Re:	PC #:	B1103915
	Commercial Plan Review Dated:	8.17.11
	Project Name:	Chase – CPC Alton
	Address:	1801 Alton Road
	Occupancy:	B

(Revision 3, PLAN REVIEW COMMENTS, dated 04-22-2013)

JPM CHASE - Alton Road
CPC Interior Renovations
1801 Alton Road
Miami Beach, FloridaEXIT 2
3'-0"
(34" CLEAR)0 4' 8' 16'
SCALE: 1/8" = 1'-0"AREA OF
WORK
FURNITURE
ONLYAREA OF
WORKEXIT 2
6'-0"
(68" CLEAR)AREA OF
WORK

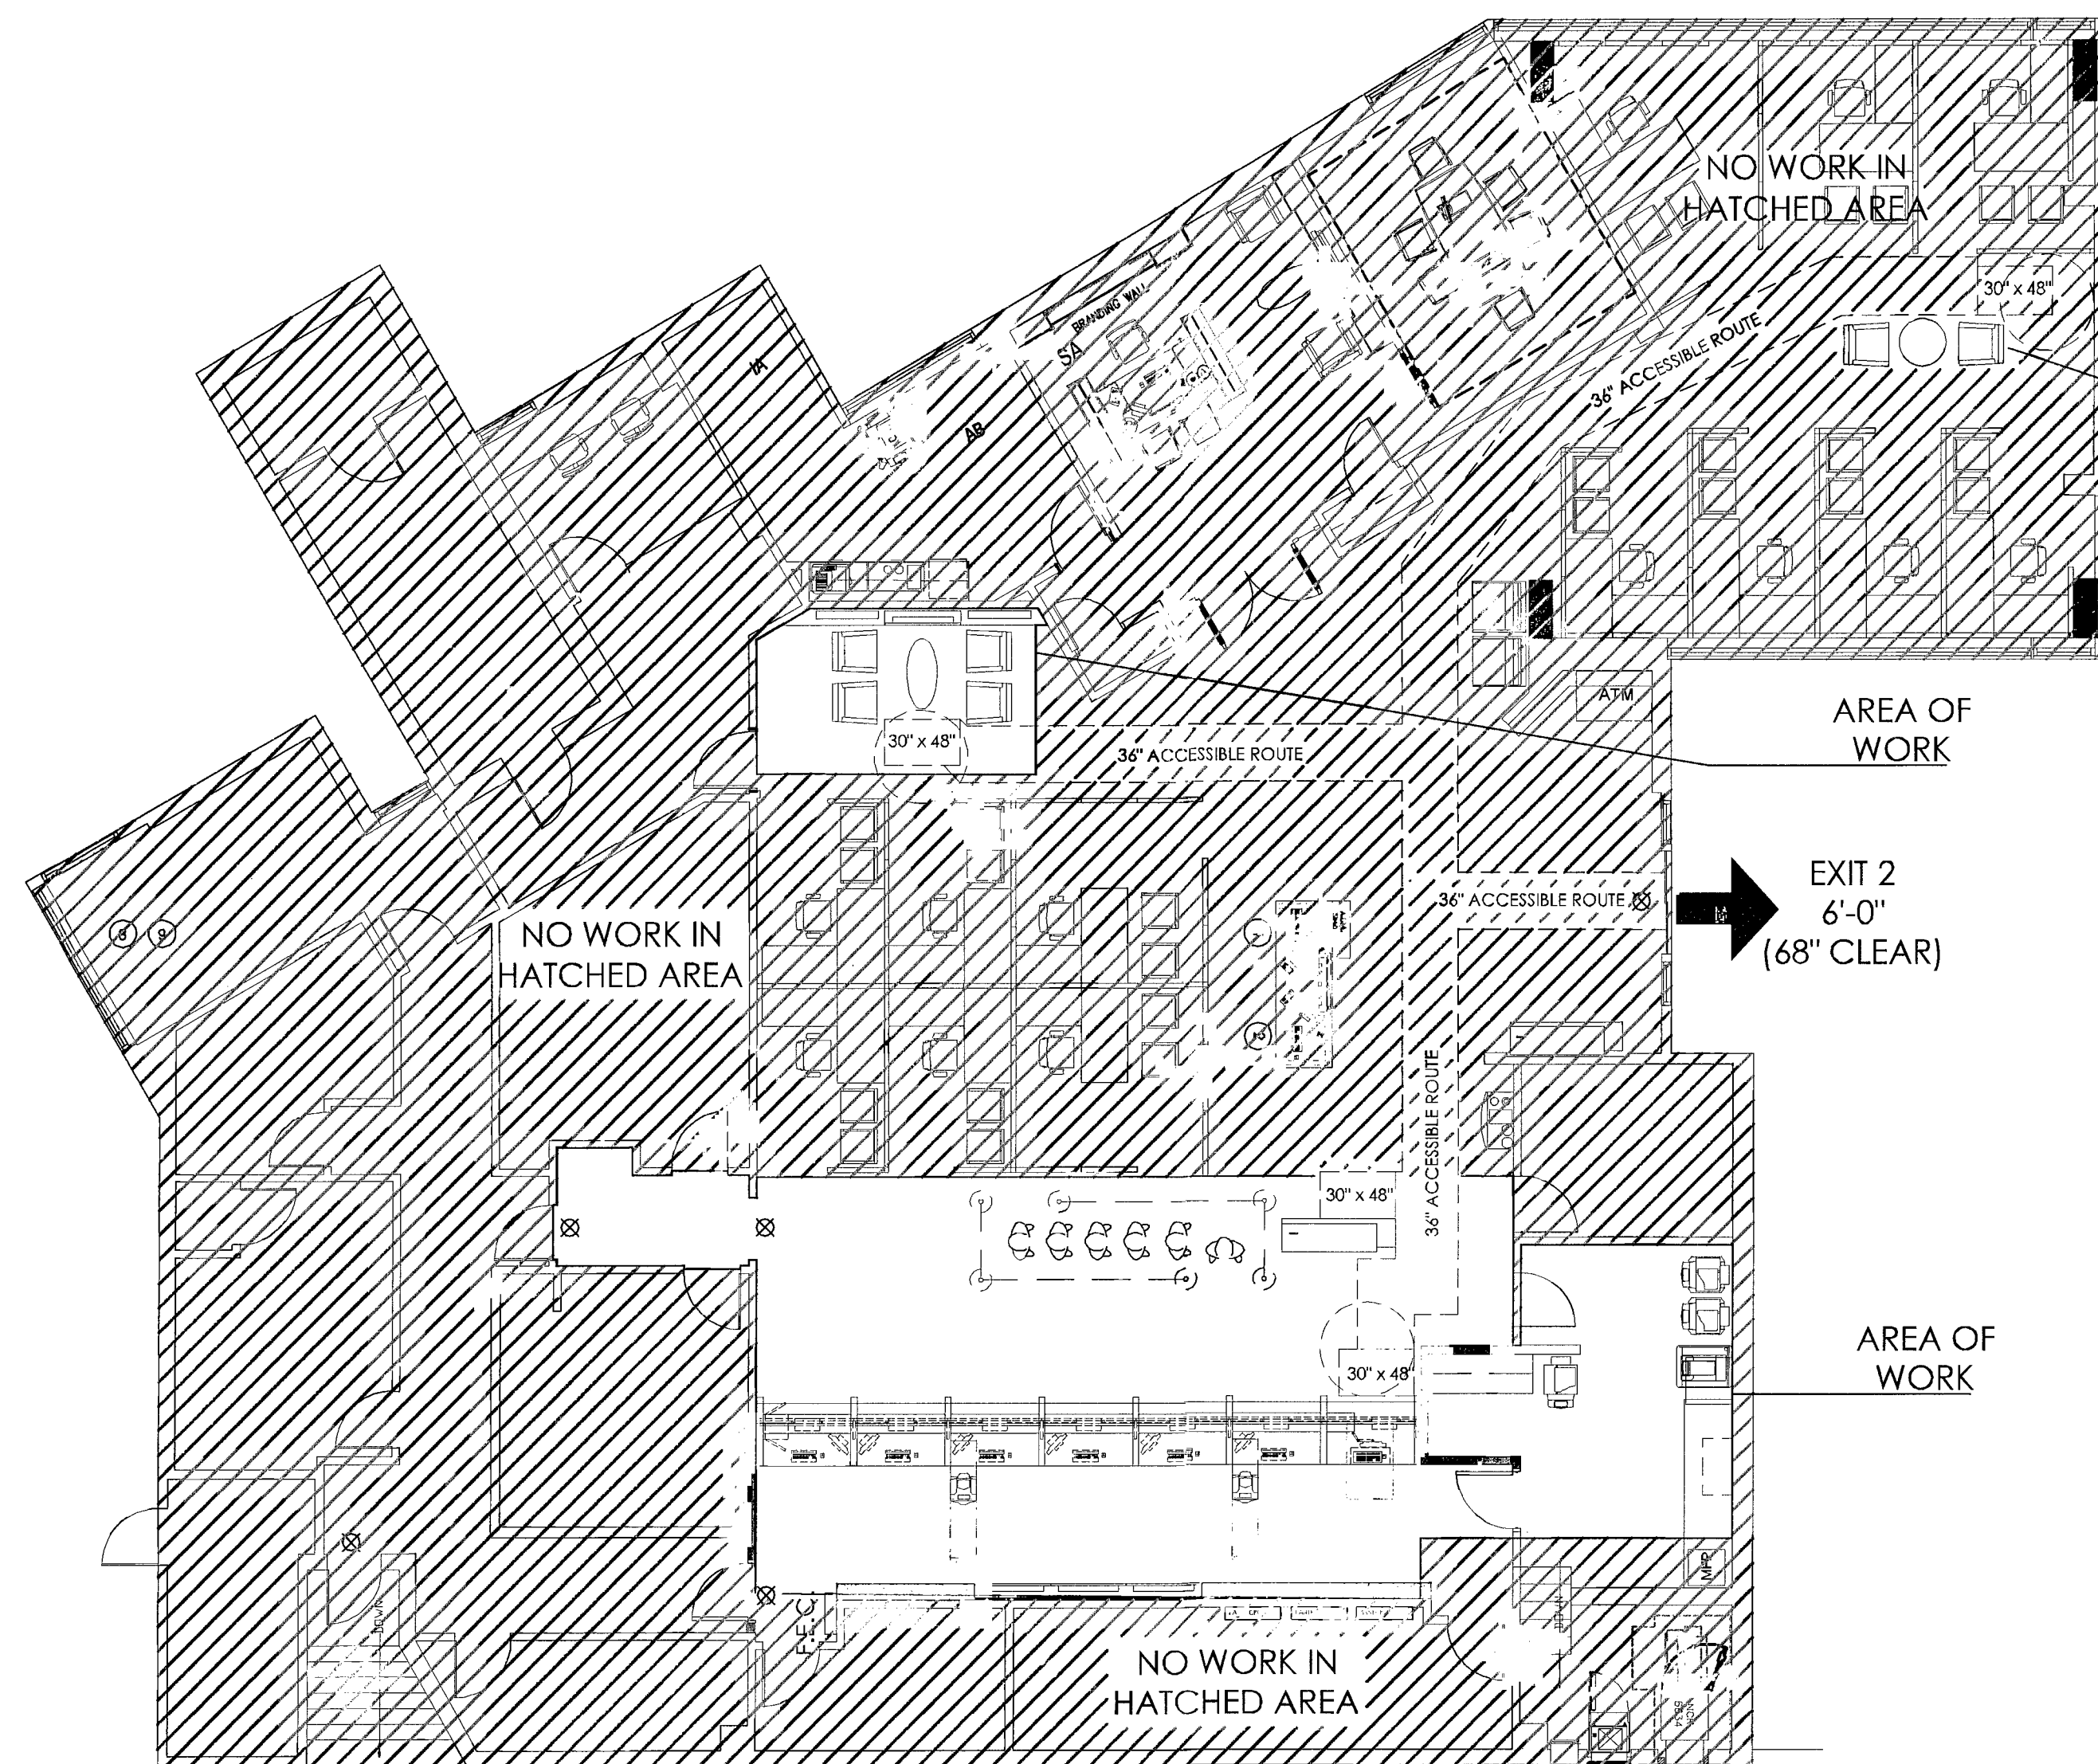
- 1. Sheet A0.0: Code information: Applicable codes: Show on plans code in effect in compliance with FBC §107.2.1: 2010 Florida Building Code, Existing Building. There are no valid 2012 amendments to the Florida building code.**

2. **Sheet A0.0: Provide number of stories of building. Clarify if floor ceiling assembly over work area is a fire rated separation for occupancy above. If so, on plans provide a cross section and a UL detail (or equal) for the fire rated floor-ceiling assembly in compliance with FBC chapter 7.**

5. **Sheet A0.0: Show accessible route to comply with FAC §206.**

- 1. Sheet A0.0: Provide scale to verify compliance with the ffpc 2010 table A7.6 for business.**

RESPONSE: *Applicable Code section has been corrected. Please refer to attached revised sheet A0.0.*

RESPONSE: The existing building has two stories. As per telephone discussion between Mr. Schaad (City of Miami Beach) and Caleb Janus (BDG Architects) on March 25, 2013, on-site investigations have been made, which indicate that the construction of the floor/ceiling assembly is poured concrete slab on poured concrete beams. As discussed, it is not possible to determine the exact nature of the materials and thickness of the structure. However, the existing floor / ceiling assembly is not being altered or affected in any way by the proposed renovation. Please refer to attached revised sheets A0.0 & A5.1 detail 8, for a schematic section of the existing condition as requested.

RESPONSE: Please refer to attached revised sheet A0.0 for accessible route.

RESPONSE: Please refer to attached revised sheet A0.0 (Cover Sheet) with Life Safety Plan shown at scale.
